R610 St. Patricks Junction Upgrade Scheme

Stage 1 Road Safety Audit

July 2026

Document reference: 100287864-MMD-REP-RSA-2026-030 | B

Figure 2.2: Proposed junction layout

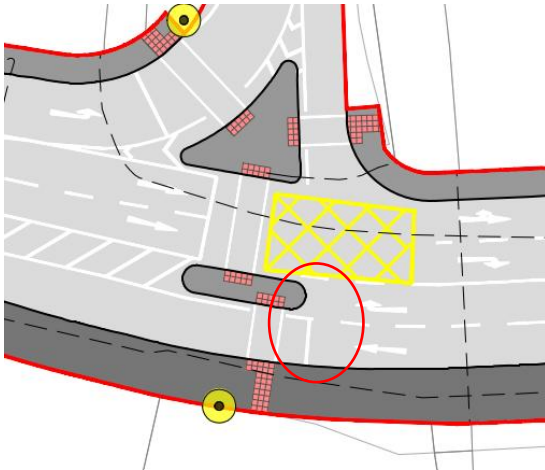
Summary: Right turning vehicles may believe they are uncontrolled and turn at the same time as eastbound traffic potentially leading to turning related collisions.

A stop line has been provided for westbound traffic on Rochestown Road, however right turning traffic is to pass in front of the traffic island. The provision of a controlled pedestrian crossing on the N28 on-slip indicates that the Rochestown Road right turn lane will be required to be signal controlled. However, the presence of the traffic island, potential positioning of traffic signals and lack of a stop line may mislead right turning motorists into believing they are not controlled. Vehicles turning right uncontrolled against eastbound traffic could result in vehicles turning across the path of ahead traffic increasing the risk of collisions. In addition, vehicles may fail to stop for the pedestrian crossing leading to an increased risk of collisions with crossing pedestrians.

Modify the signal-controlled crossing arrangement and associated traffic signal equipment and Stop lines so that the highway arrangement and signal control is clear to all users.

Figure 2.3: Proposed markings within the junction.

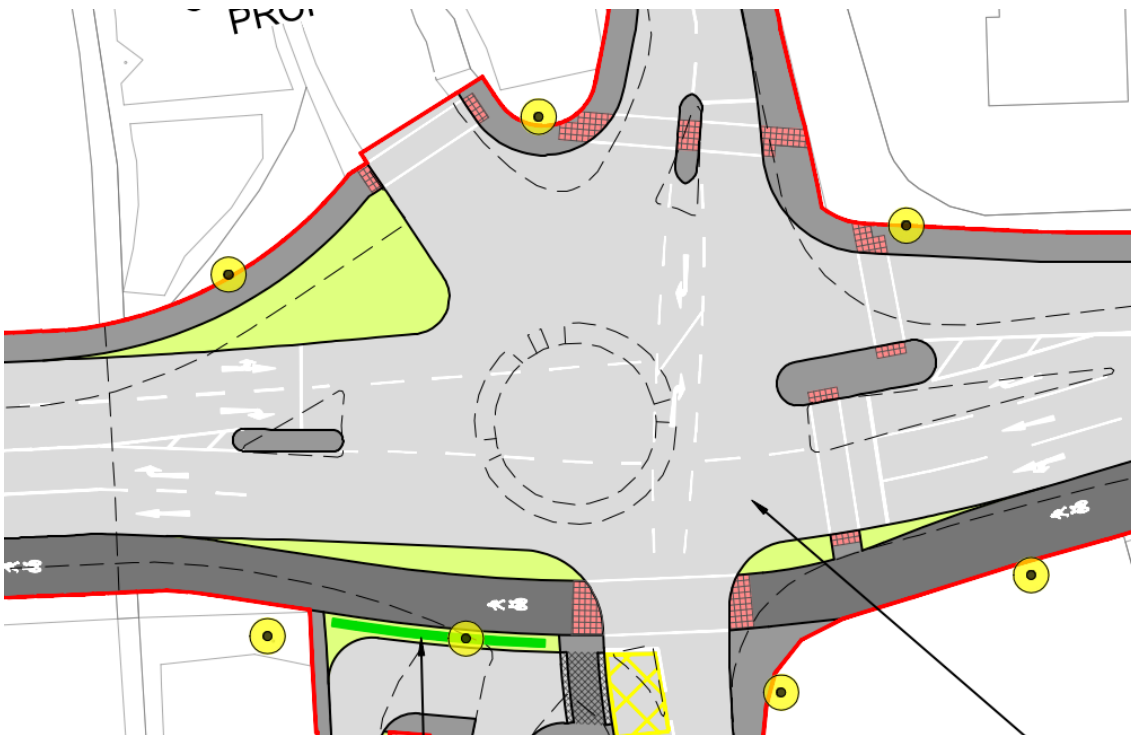
Summary: A lack of clear markings for right turn manoeuvres increases the risk of turning related collisions at the junction.

A number of issues have been identified with the markings within the Rochestown Road, N28 off-slip, Woodbrook and Mount Ovel Junction which could lead to turning related collisions.

- Right turn lanes have been marked out for drivers turning from Woodbrook and Mount Ovel, however these are minor arms with low traffic flows. The markings also extend through the Rochestown Road westbound carriageway and therefore the junction layout may not be clear for other motorists using this junction.
- The right turn lane from Woodbrook guides right turning motorists towards the stop line for eastbound traffic on Rochestown Road.
- No right turn arrow(s) has been shown within the wide right turn lane for Rochestown Road traffic and with the other markings it may not be clear where traffic, particularly from the east, is to wait and turn.

Modify the right turn lanes so that the highway layout is clearly understandable to road users.

Figure 2.4: Proposed pedestrian crossing layout.

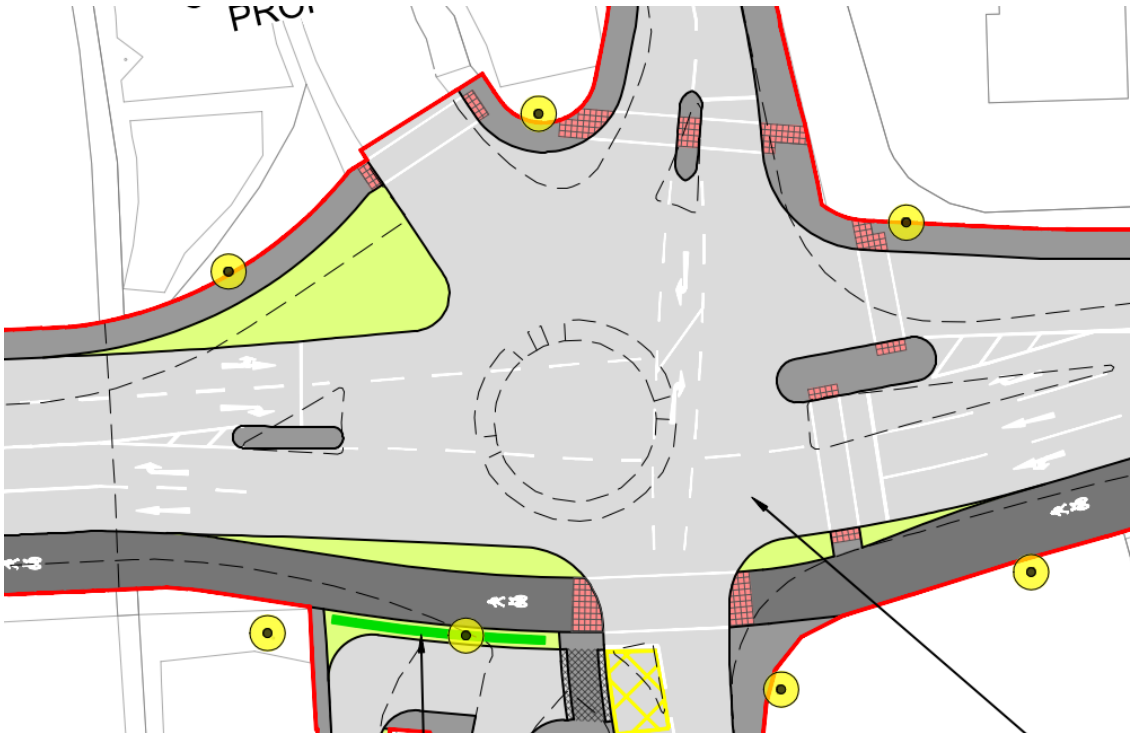
Summary: Incorrect tactile paving may mis-lead sight impaired pedestrians increasing their vulnerability to being struck.

Controlled crossings are proposed over Westbrook, Rochestown Road and Mount Ovel. The tactile paving however is shown in multiple places without the stem which indicates to blind and sight impaired pedestrians that it is a controlled crossing. The lack of a stem may mislead users who may believe it to be an uncontrolled crossing, increasing their vulnerability to being struck by passing motorists.

Provide the correct tactile paving in line with relevant guidelines to reflect they are controlled crossings.

Figure 2.5: Proposed layout at Brookfield.

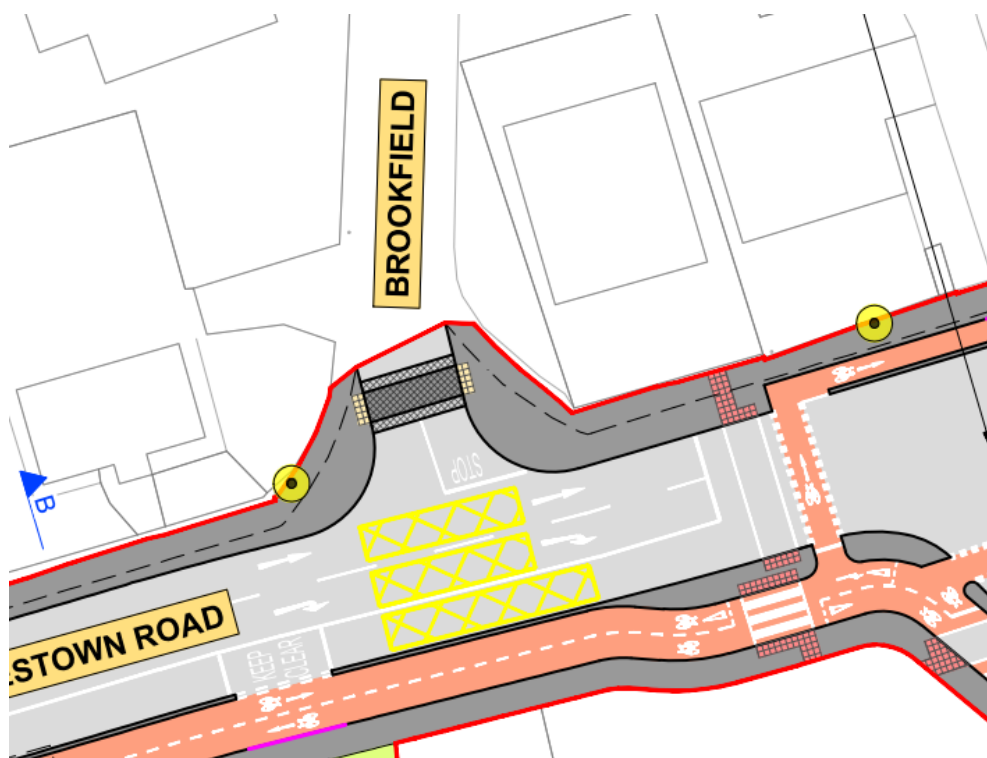
Summary: Lack of cycle provision for cyclists on the northern side of Rochestown Road to access the cycle track may lead to use of the pedestrian or unidirectional cycle crossing potentially resulting in conflict.

Should cyclists from Brookfield on the northern side of Rochestown Road wish to join the segregated cycle track on the southern side of Rochestown Road, they will be required to cross three lanes of traffic and be vulnerable to colliding with motorists. Alternatively, they may use the signalised pedestrian or unidirectional cycle crossing at Clarkes Hill and be at risk of colliding with pedestrians or cyclists.

Provide appropriate links between the northern and southern sides of Rochestown Road, this may involve providing a bi-directional cycle track across Rochestown Road.

Figure 2.6: Proposed cycle track layout at Clarkes Hill.

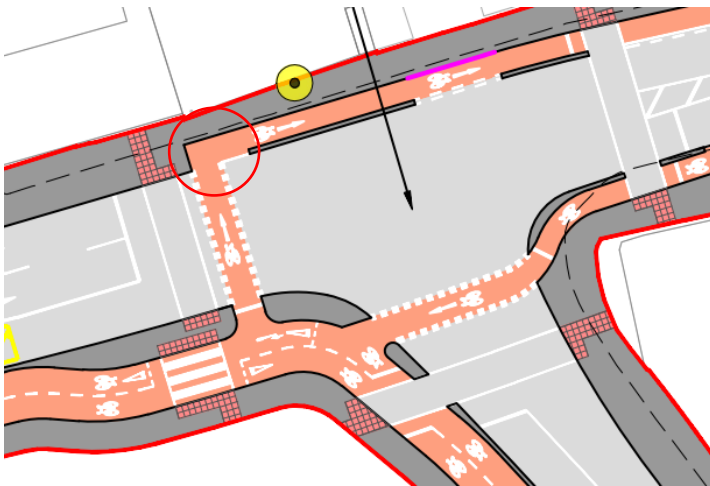
Summary: Sharp turn for cyclists may result in the kerb being clipped or over ridden leading to falls from bikes.

Cyclists from the southern side of Rochestown Road crossing to the northern side and heading east are expected to make a 90-degree turn. This sharp turn could be a difficult manoeuvre for some bikes to undertake which could result in the kerb being clipped or over ridden. Should bikes strike the kerb, it increases the risk of cyclists being unseated which may result in cyclists falling from their bikes leading to personal injury.

Relax the angle of the cycle track so that it is more gentle and easier for cyclists to turn.

Figure 2.7: Proposed cycle track layout at Clarkes Hill.

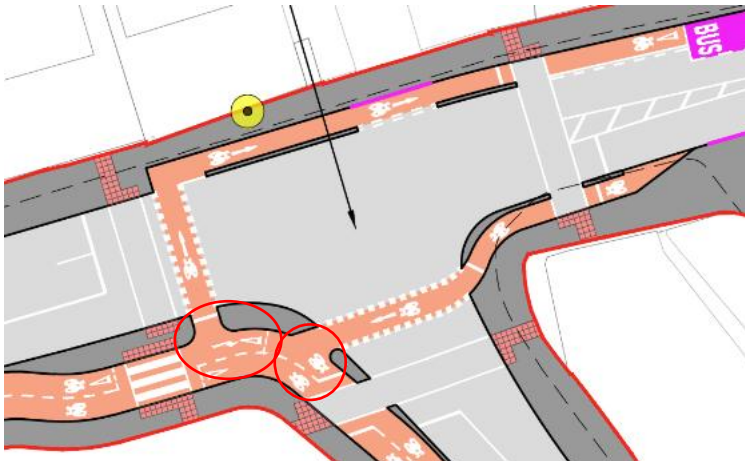
Summary: Insufficient length of cycle track may lead to conflict with other cyclists.

The layout proposes locations where cyclists are to stop or give-way to other cyclists. The Road Safety Audit Team is concerned that cyclists waiting at these Stop and Give-way lines may block the path for other cyclists continuing on a different route potentially leading to conflict between cyclists.

Provide a sufficient length of cycle track for cyclists to wait without hindering other cyclists travelling in a different direction.

Figure 2.8: Proposed arrangement at Clarkes Hill.

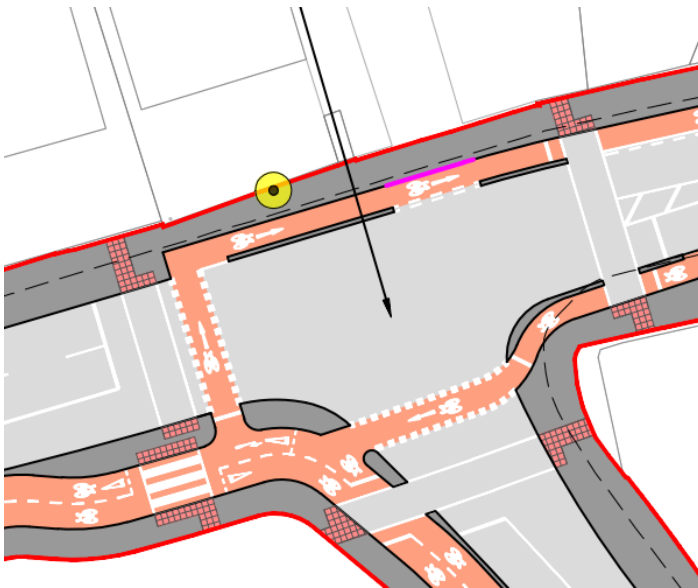
Summary: Lack of control for those properties entering / exiting within the signalised junction could result in rear end shunt and turning related collisions.

Access to several properties is proposed within the signalised junction which do not appear to be controlled. The lack of control could result in motorists exiting the properties into the path of other traffic flows that have a green traffic signal which could result in conflict. Furthermore, through traffic may not expect vehicles to be slowing to turn within the junction leading to rear end shunt related collisions.

Provide signal control for those exiting from Clarkes Hill northern arm. The junction may need formalising and potentially narrowing

Figure 2.9: Proposed Crossings at Clarkes Hill.

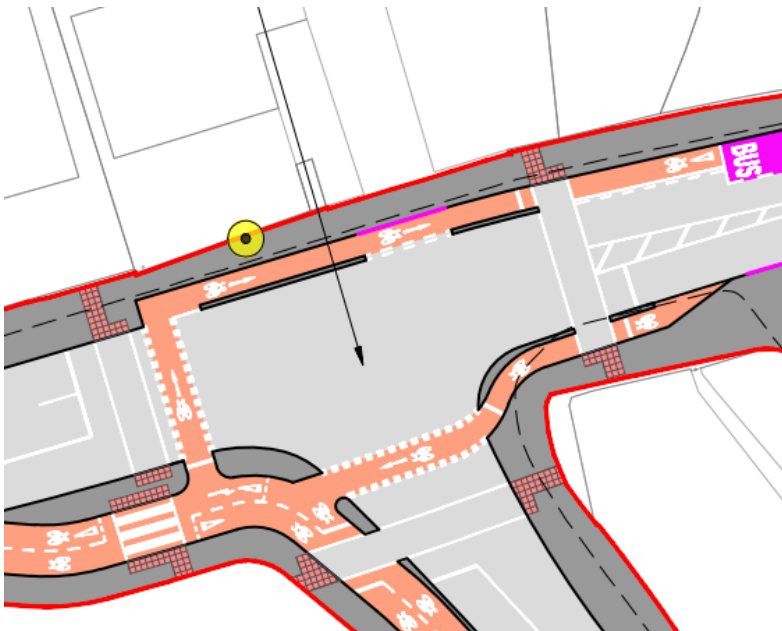
Summary: Lack of appropriate green times for length of crossing may result in pedestrian collisions with motorists and cyclists.

The crossing widths, particularly on Rochestown Road eastern arm and Clarkes Hill are wide taking into account crossing of the cycle track. Should the pedestrian green times not be sufficient in length for pedestrians to complete their crossing movement, it could result in conflict with motorists or cyclists who may commence their movement before a pedestrian has completed their crossing.

Provide sufficient pedestrian green times to allow a pedestrian to fully cross the carriageway and cycle track prior to other signal stages receiving a green light.

Figure 2.13: Proposed layout at Riverside junction.

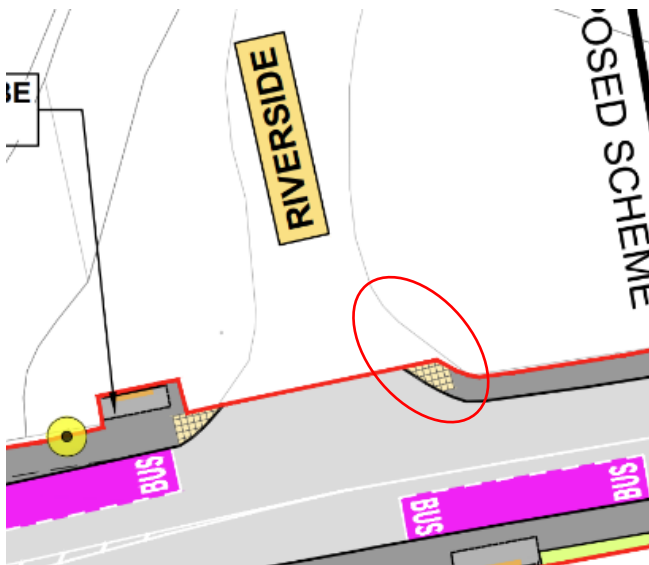
Summary: Inappropriate tie in on Riverside could result in pedestrians walking within the carriageway at risk of conflict with motor vehicles.

The kerb alignment is to be amended, however it is not clear how the kerb is being modified and connecting with the existing provision on Riverside. Should the proposed footway fail to connect with the existing footway provision it could result in pedestrians being within the carriageway at risk of conflict with motorists.

Continue the footway from Rochestown Road into Riverside.

Figure 2.14: Proposed bus stop opposite Riverside.

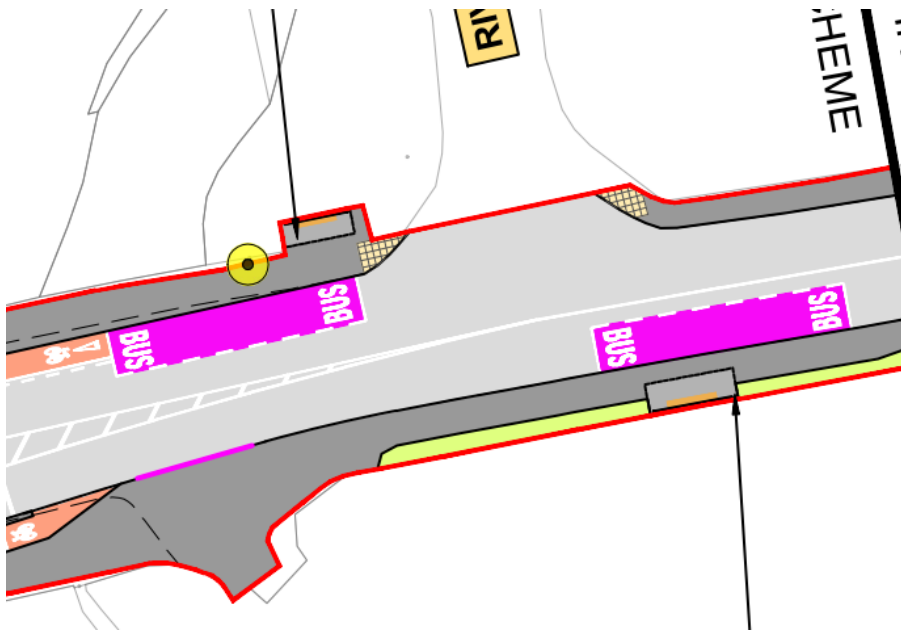
Summary: Bus stop opposite junction may lead to vehicles overtaking a bus at the same time a vehicle exits Riverside leading to turning related collisions.

The bus stop on the southern side of Rochestown Road is proposed almost opposite Riverside. There is concern that a westbound vehicle on Rochestown Road may attempt to overtake a stationary bus at the same time a vehicle pulls out of Riverside, increasing the risk of turning related collisions.

Relocate the bus stop further away from the junction.
